TO: Town of Harrison, Planning Board

RE: Accordia Harrison Urban Renewal LLC
Block 133, Lots 1.03, 1.04 & 1.05
Amended Preliminary/Final Major Site Plan and C Variances

DATE: June 9, 2020

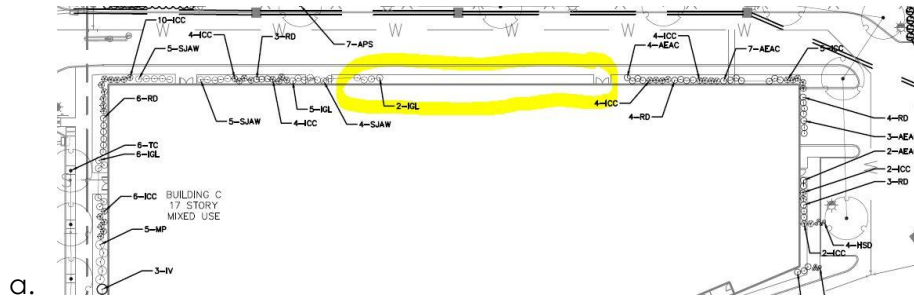
18. The ground floor of Building B appears as two separate buildings, but is actually one building of varying heights, bisected by a covered driveway. The applicant should provide testimony regarding the design of the Building B and how the interior circulation will

function. The applicant should confirm the height of this covered driveway to confirm an enclosed tunnel feeling will be avoided.
